Fresno County, California 08-AFC-12

San Joaquin Solar 1 & 2 Hybrid Project

Supplemental Information
In Response to CEC Data Requests, 08-AFC-12

Figure 5.5-5 - General Hydrogeologic Conditions

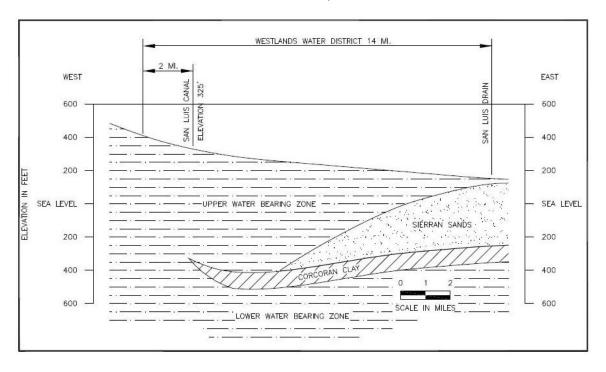
Data Adequacy Request 2: Please provide figures depicting hydrogeologic conditions, groundwater bodies or related geologic structures.

Figure 5.5-1 in the AFC presents the groundwater sub-basins in the vicinity of the project. Figure 5.5-5 (new figure) taken from Westlands Water District report entitled "Deep Groundwater Conditions Report," dated March 2008 (available online at: www.westlandswater.org/short/200805/525r07.pdf), presents a general hydrogeologic condition of the valley adjacent to Coalinga within the Westlands Water District. This report, available from Westlands Water District, provides general hydrogeologic conditions in the area. The project is located several miles west of the San Luis Canal as depicted on Figure 5.5-5. The existing onsite well (as currently screened) likely draws water from both the upper and lower water bearing zones. More detailed hydrogeologic conditions at the site will be provided along with the aquifer test results. Note that the project is located within the Pleasant Valley Groundwater Sub-basin and Water District (west of Westlands Water District), so the information provided in the Westlands Water District report, while informative in a general sense, may not reflect actual conditions within the Pleasant Valley Water District.

FIGURE 5.5-6 - GENERAL SITE GRADING

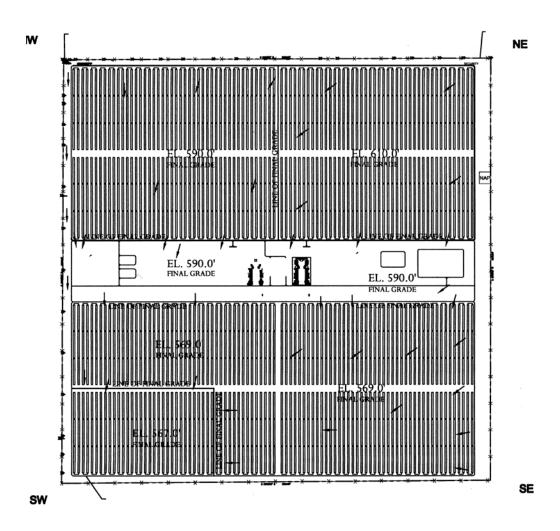
Data Adequacy Request 9: Please provide a description of design storm. Need storm water

The currently proposed design will sheet flow accumulated runoff through each of the four main pad areas. Flows may be concentrated at select locations including: roadside swales, road cross culverts, terrace downdrains, and at the entrance to the infiltration area in the southwest corner of the site. The infiltration area will be designed to accept and infiltrate annual runoff volumes to reduce post project flows to at or below existing levels. Accumulated runoff that cannot be stored and infiltrated will be discharged out of the basin in a controlled method to prevent erosion at the outlet and receiving water. Figure 5.5-6 (shown below) shows the general pad grades (610 feet in the northeast quadrant, 590 in the northwest quadrants, and 567 within the southwestern infiltration area), general flow directions and location of the infiltration area in the southwest corner of the site.

Rainfall from each plant's solar field will continue to be drained by sheet flow. Drainage and erosion will be controlled through infiltration basins to allow the rainfall to be absorbed into the ground replenishing local ground water levels and designed to match existing runoff rates to offsite areas. The current estimate of average annual site runoff is approximately 120 acre-feet (AF), assuming 7.5 inches of annual rainfall over the 640 acre site and using a runoff coefficient of 0.3. Although the Project would increase runoff coefficients in localized areas onsite (site facilities area), the Project drainage design, along with the proposed infiltration areas in the solar field will allow percolation and evaporation to match the current runoff rates to downstream offsite areas.

SJS 1&2 Anticipated Well Performance

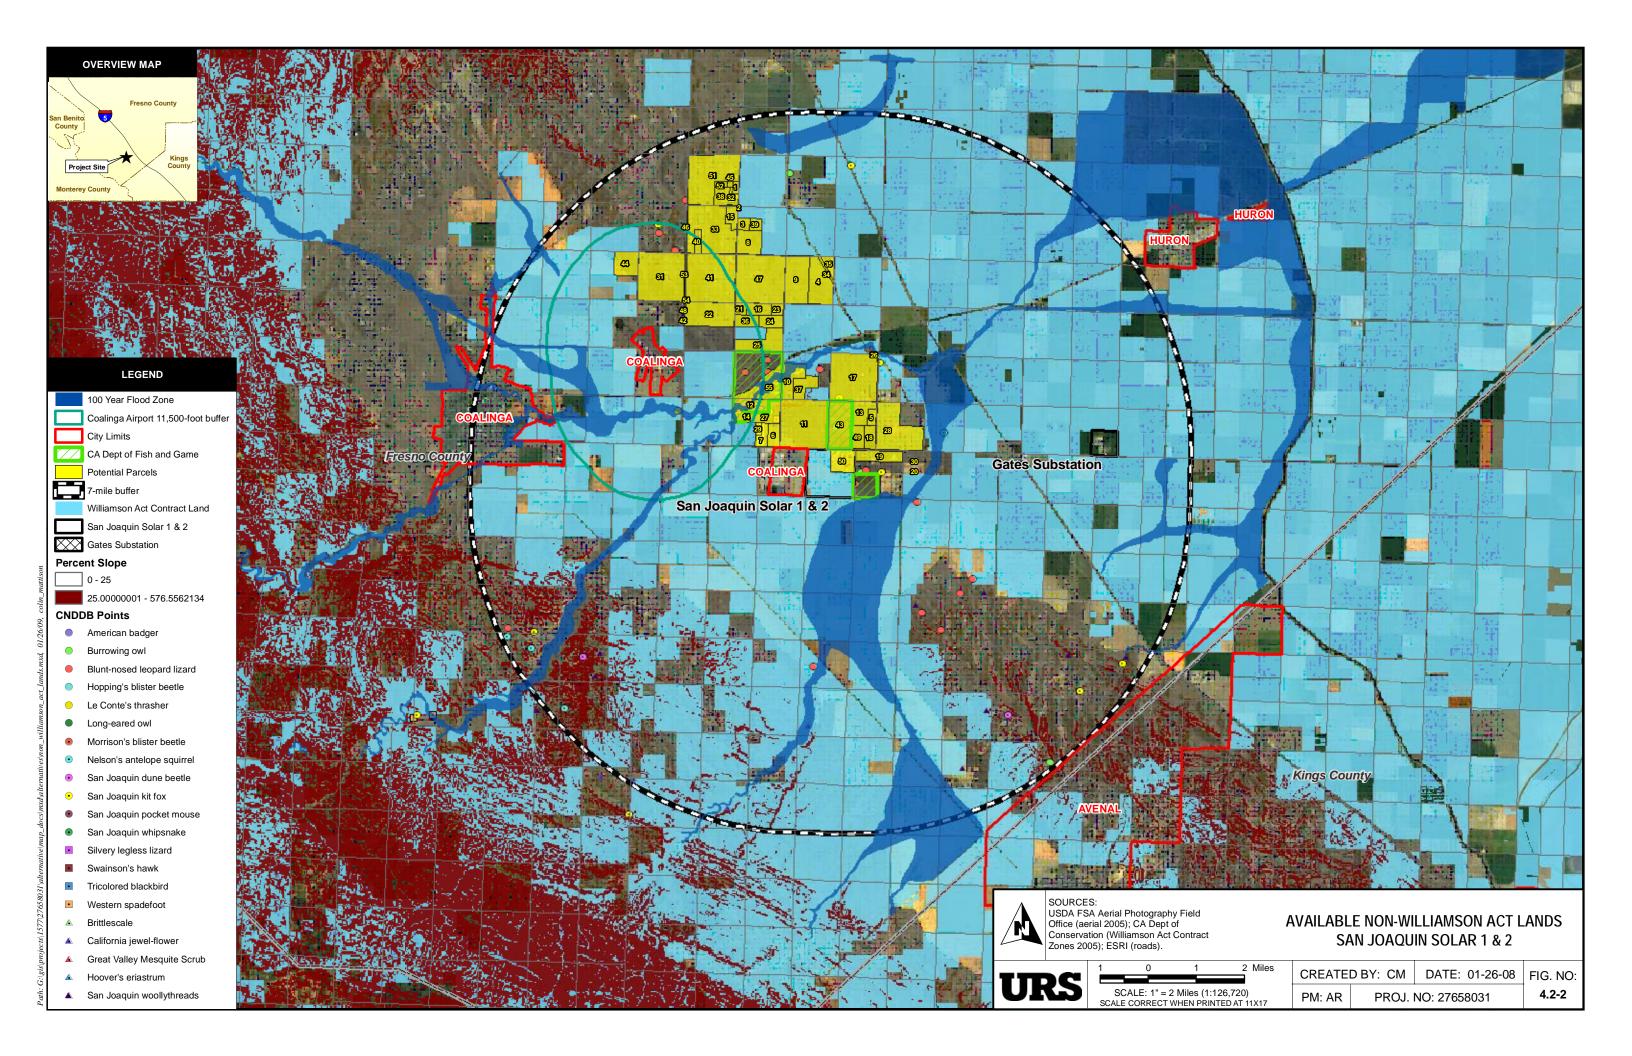
Data Adequacy Request 3: Please provide aquifer testing information to support estimated

Response: Attached is the groundwater drawdown result from a similar well located within 1
